GENERAL SUMMARY

SUM-77 / 277 / 224  
VARIOUS

**CULVERT DETAIL**  
**177 STA. 443+36**

CULVERT DETAIL  
RAMP B STA. 207+15

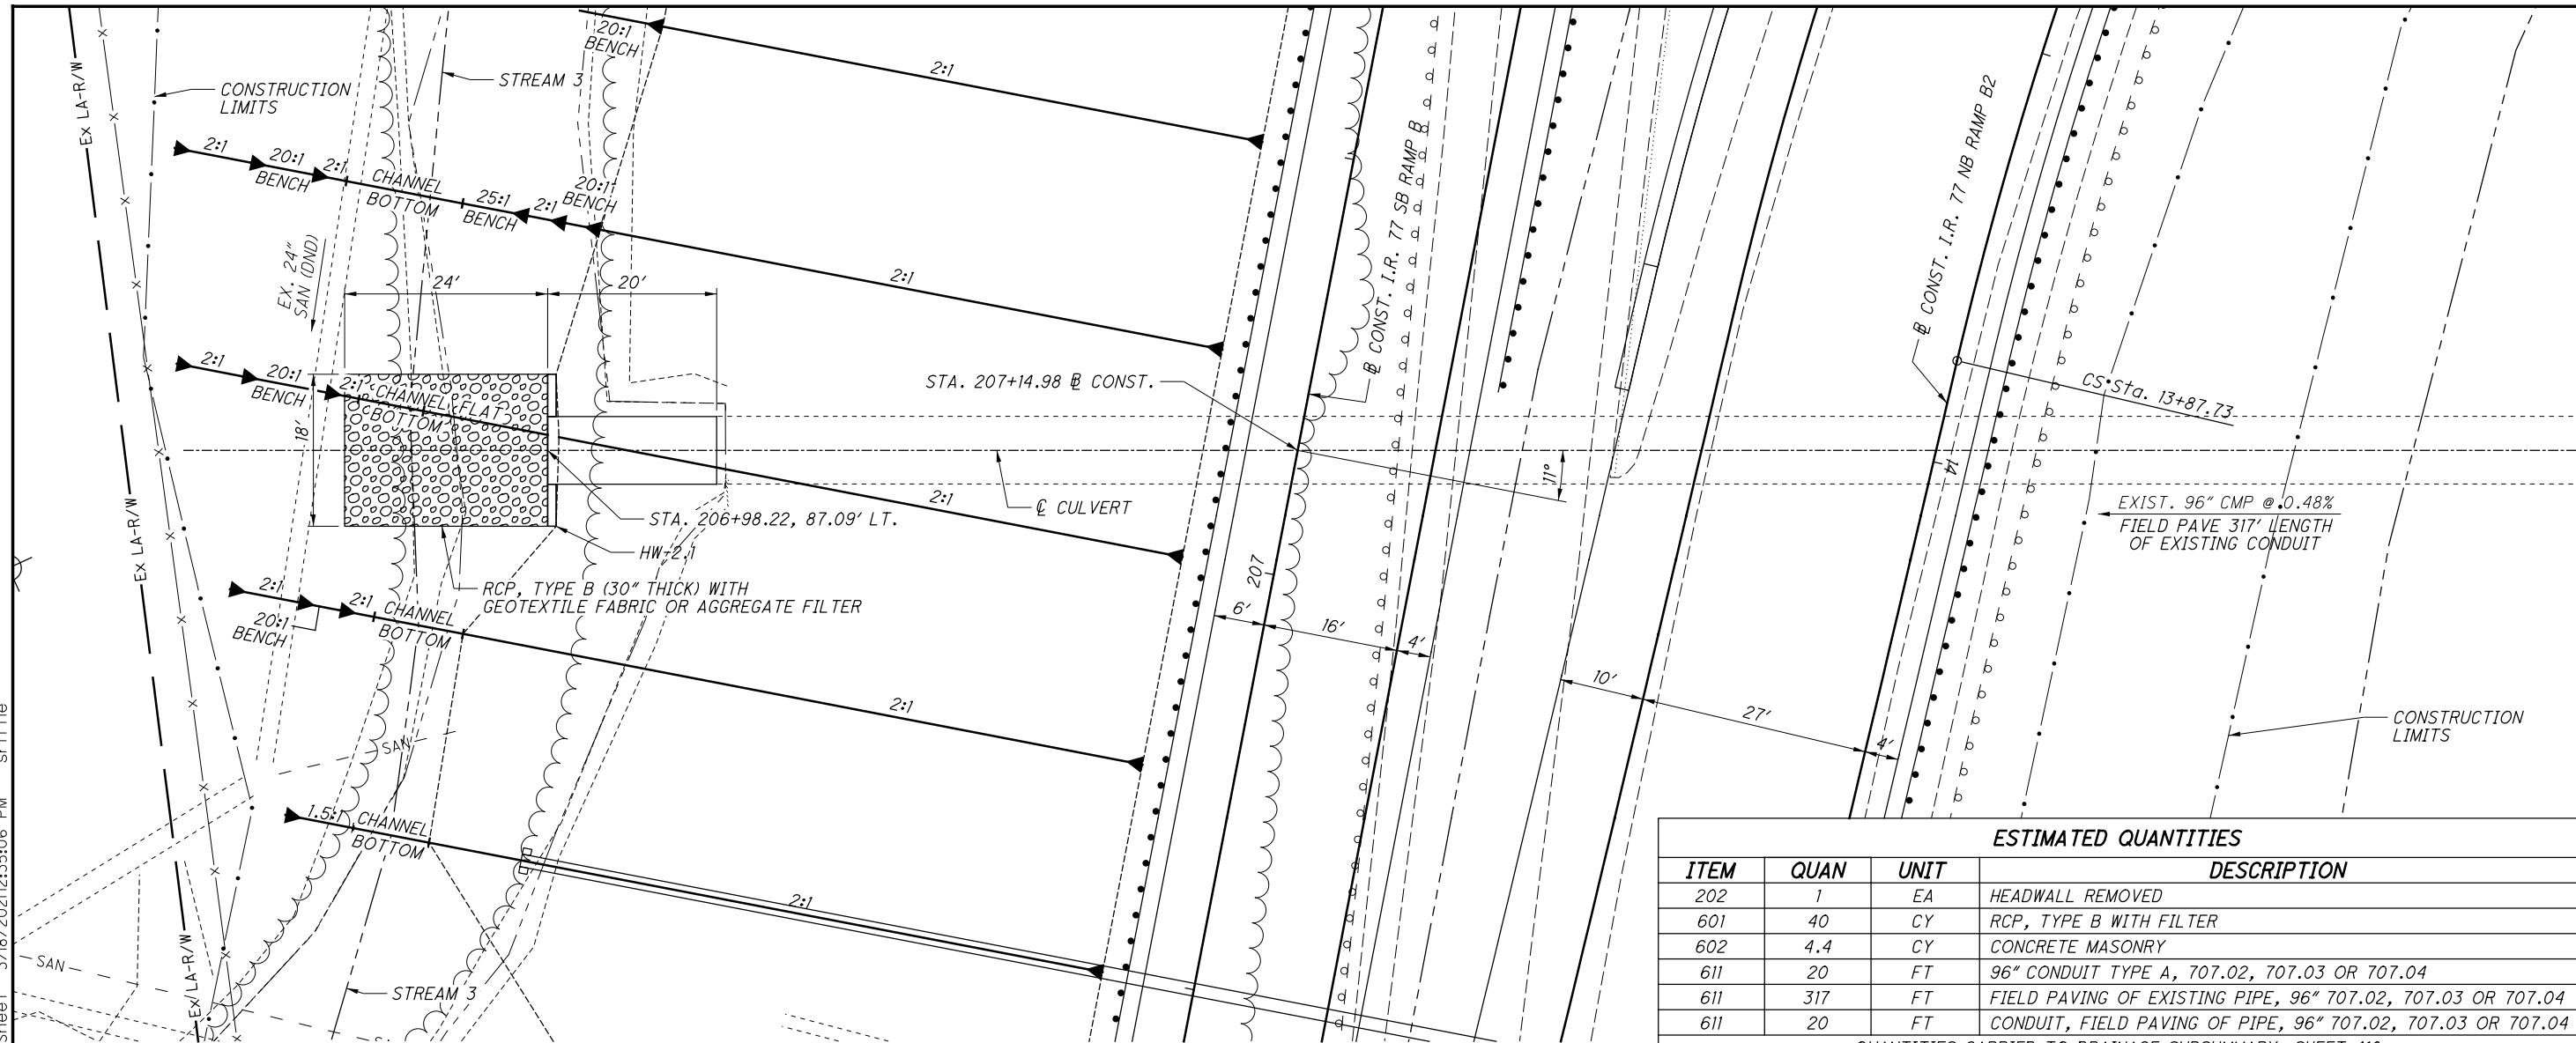
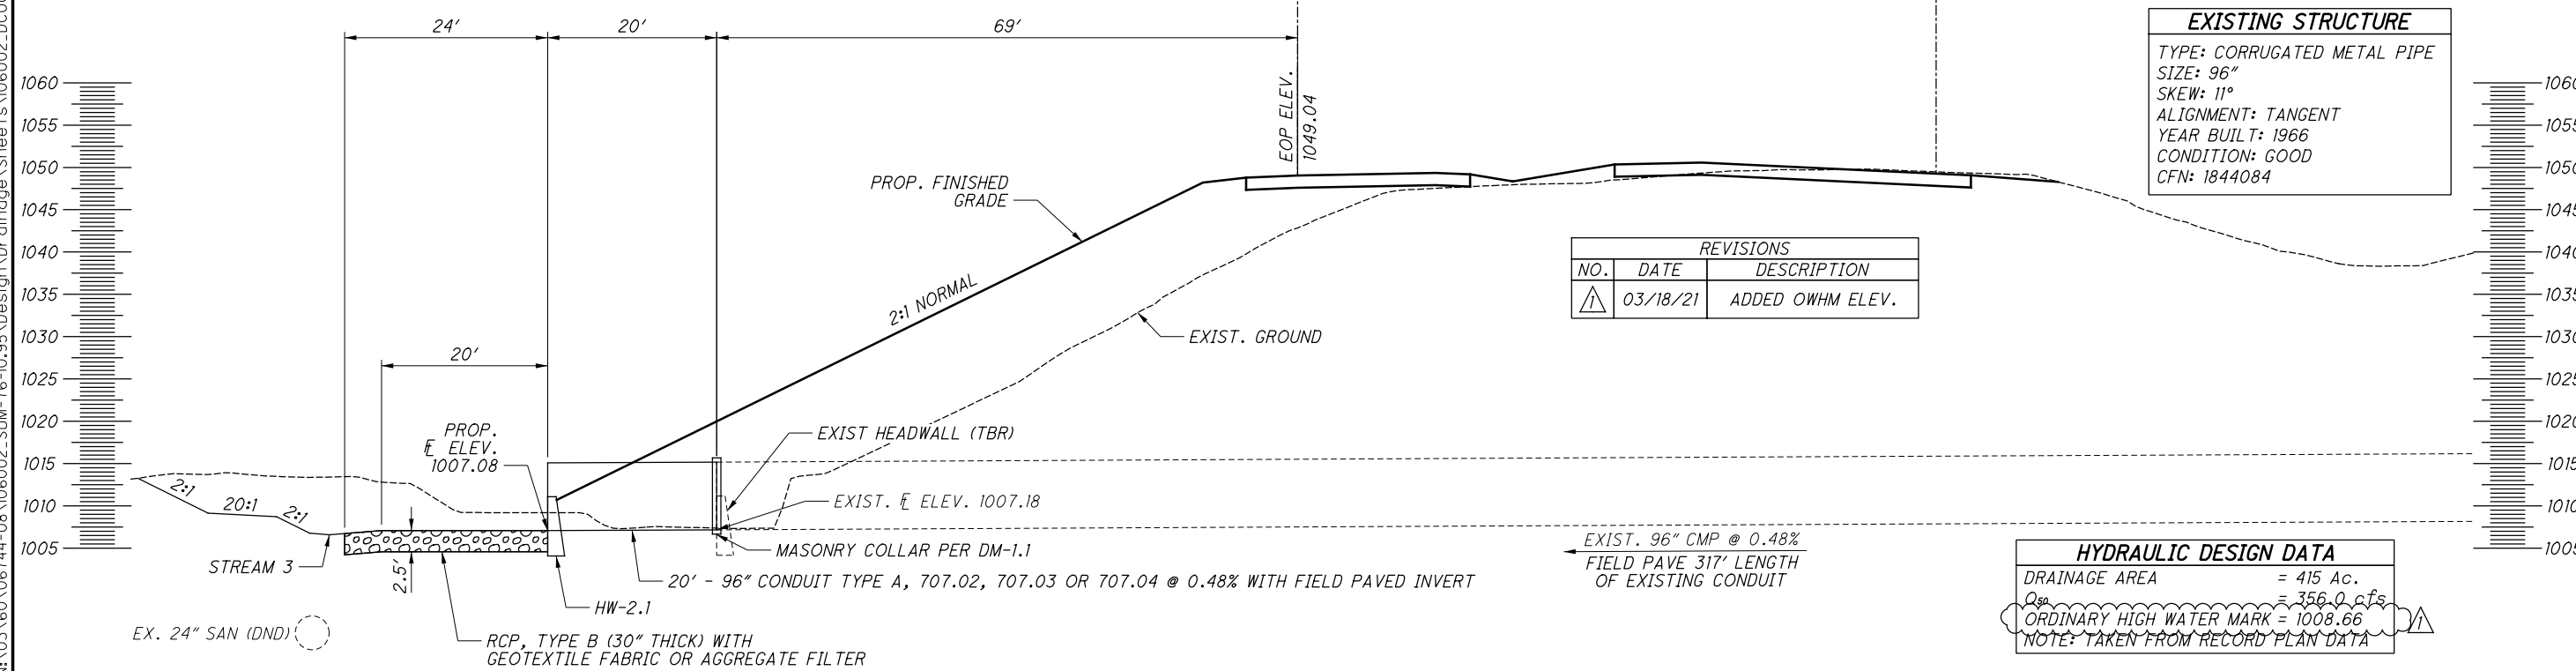
REVISIONS		
NO.	DATE	DESCRIPTION
1	03/18/21	ADDED OWHM ELEV.

**HYDRAULIC DESIGN DATA**  
 DRAINAGE AREA = 415 Ac.  
 $Q_{sp}$  = 356.0 cfs  
 ORDINARY HIGH WATER MARK = 1008.66  
 NOTE: TAKEN FROM RECORD PLAN DATA
